2-22 William Street, Granville

Urban Design Study

P18-019
26.02.2019

Figure 4: Site 1 Typical Floor Plan Compliance Comments - Level 3 (Fourth Storey) shown

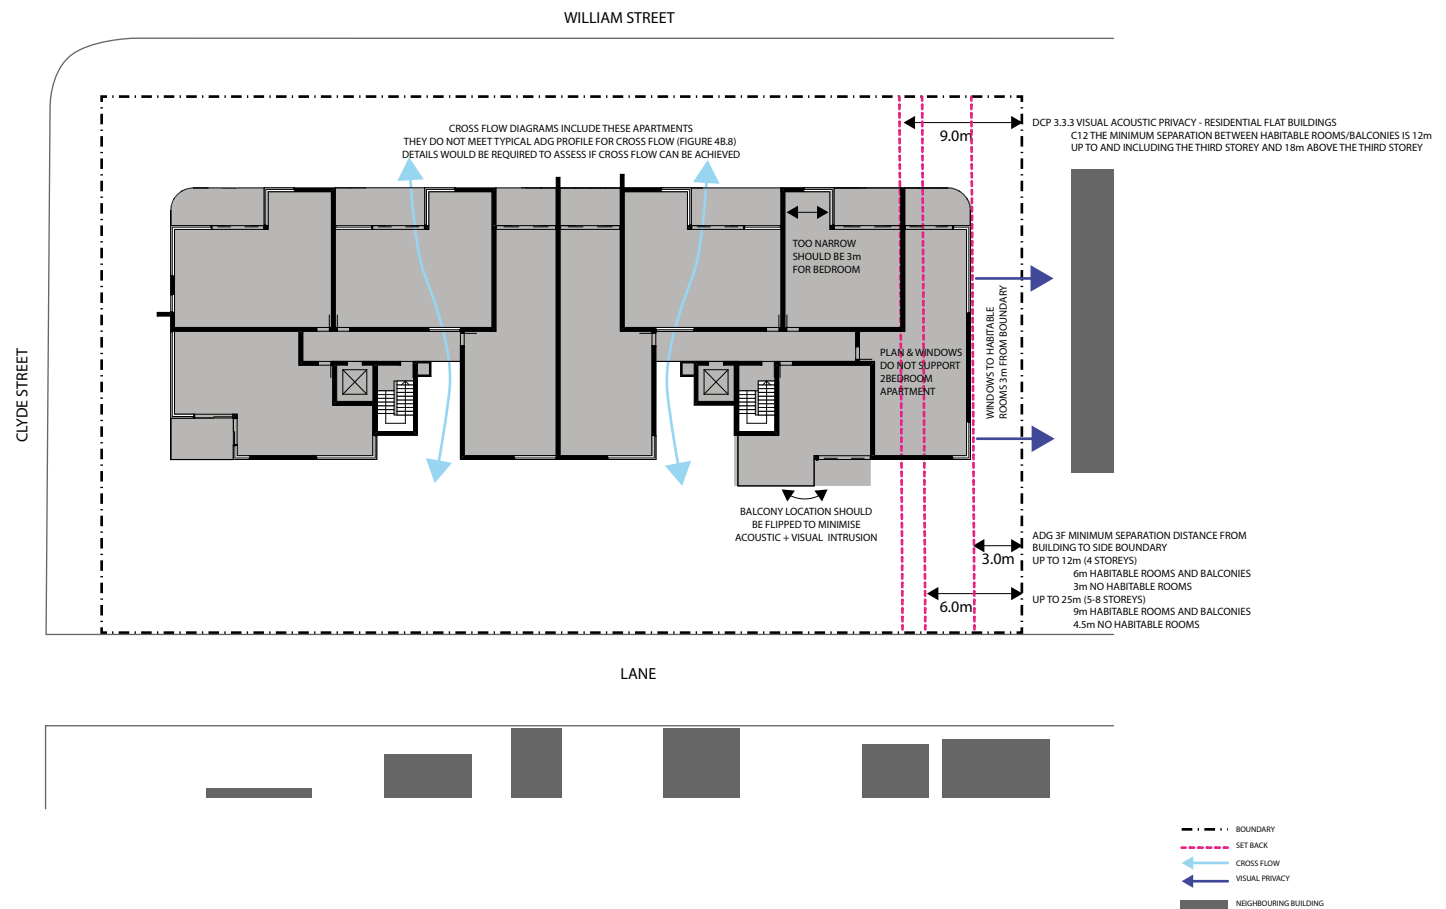
The diagram below illustrates compliance issues with the built form provided for Site 1 in the current planning proposal. These include:

- Overall height including lift overruns is 20m.
- 45 degree upper level setback not met.
- Inadequate deep soil zone for tree planting as carpark extends under communal open space.
- Rear setback is non compliant with DCP.
- Some apartments do not meet cross flow ventilation requirements.
- Does not meet ADG separation requirements on eastern boundary.
- Room dimensions do not meet ADG requirements.
- Building does not step with topography.

Figure 6: Site 1 Planning Proposal Envelope 3D massing - elevated view from Granville Diggers

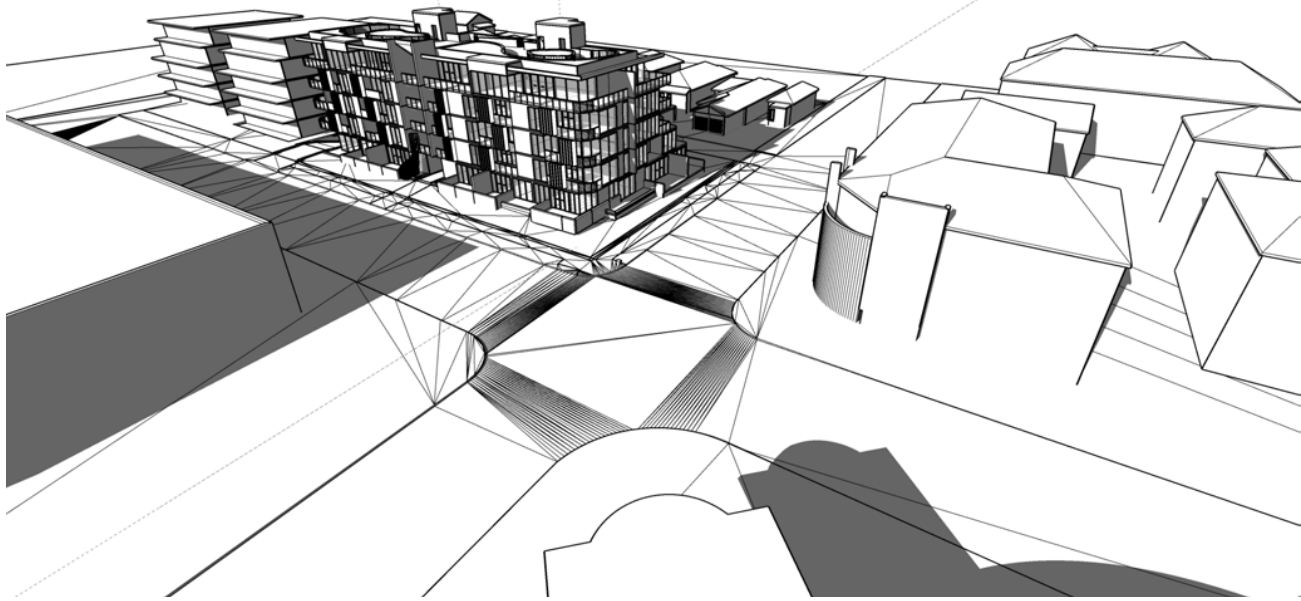
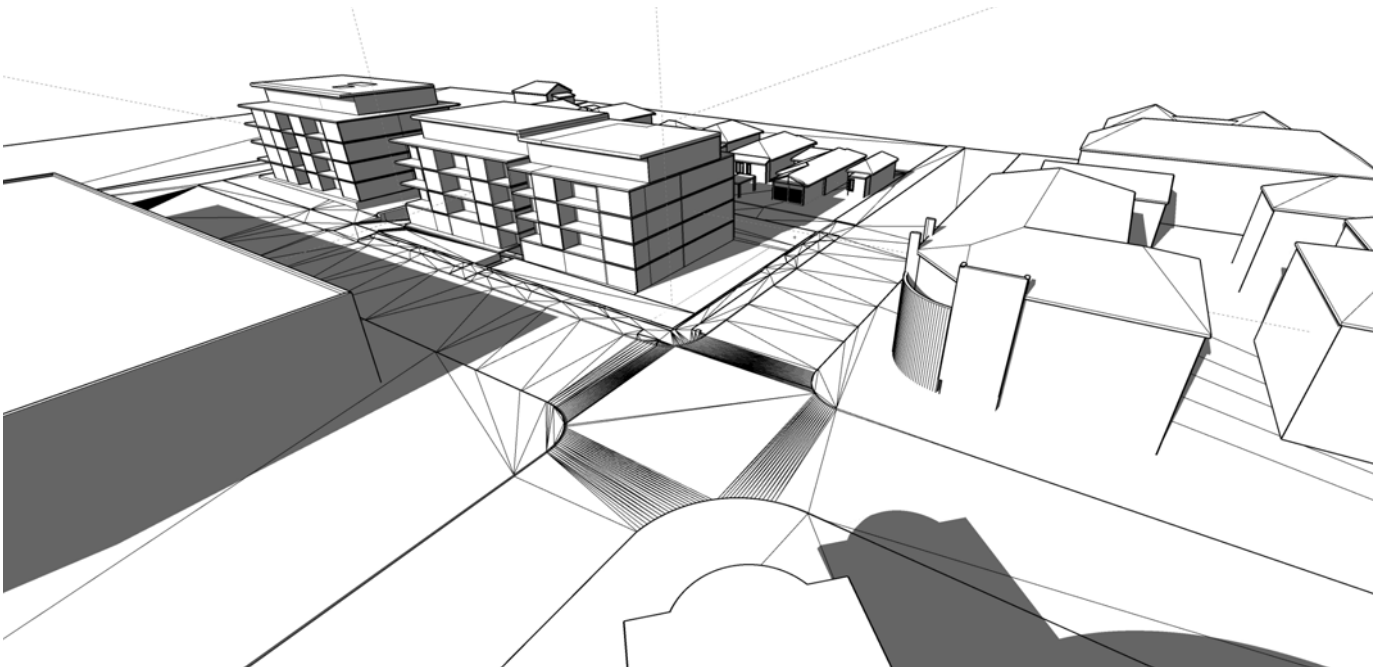
The following diagrams compare the current planning proposal (which is not compliant with the height control) against the preferred site development scenario.

Figure 10: Site 1 Planning Proposal Envelope

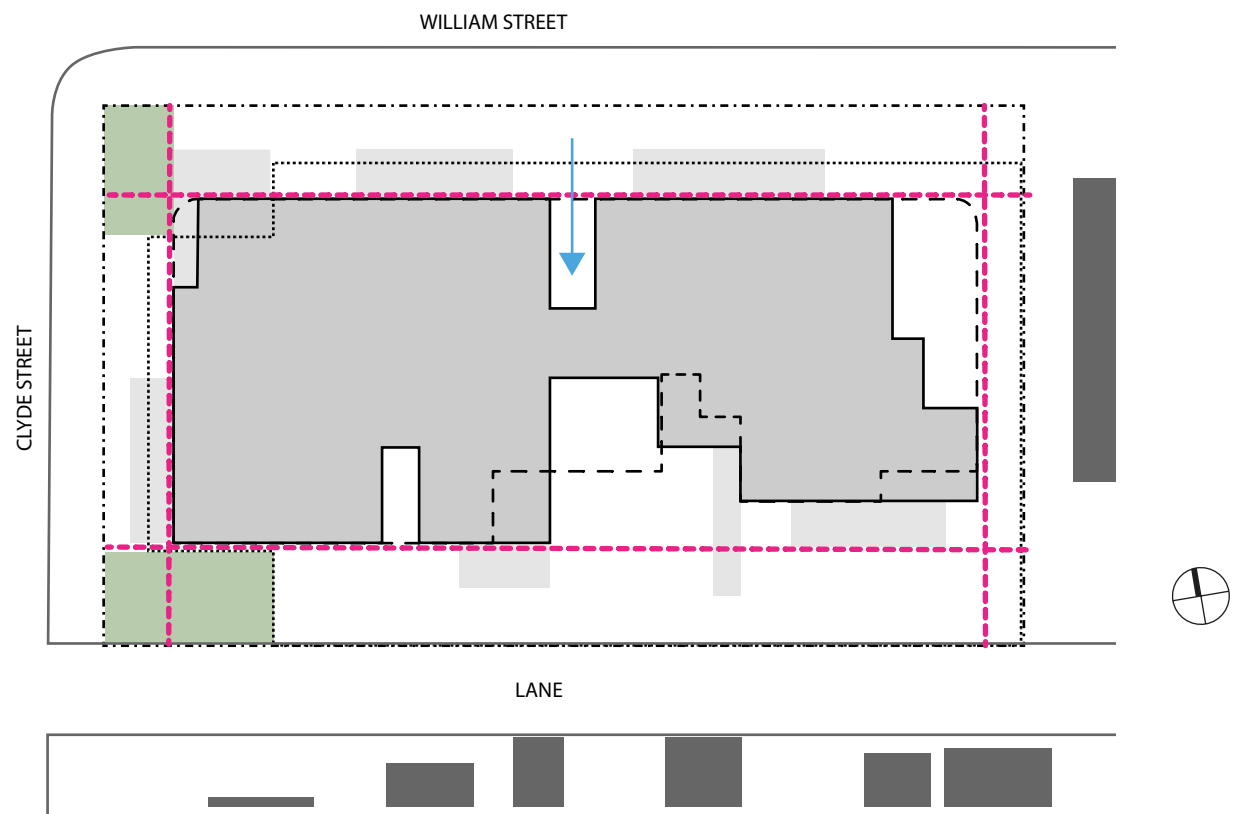
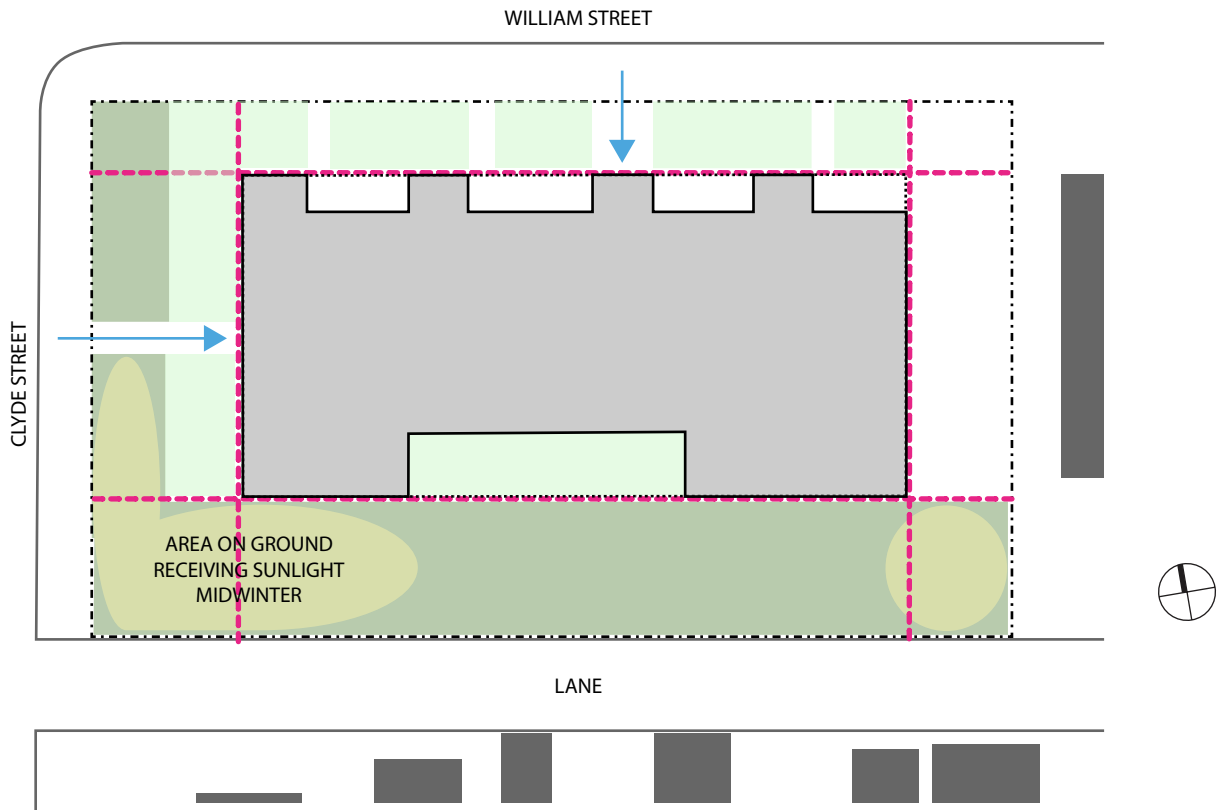
107SQM DEEP SOIL
107/2175*100=4.9%

Deep Soil Zone	107m ²	4.9% *
Communal Open Space	560m ²	26% * (rooftop)

* Does not meet DCP/ADG requirement

700 SQM DEEP SOIL
 $700/2175 \times 100 = 32.1\%$

Deep Soil Zone	700m ²	32.1% *
Communal Open Space	550m ²	25% *

* Meets DCP/ADG requirement
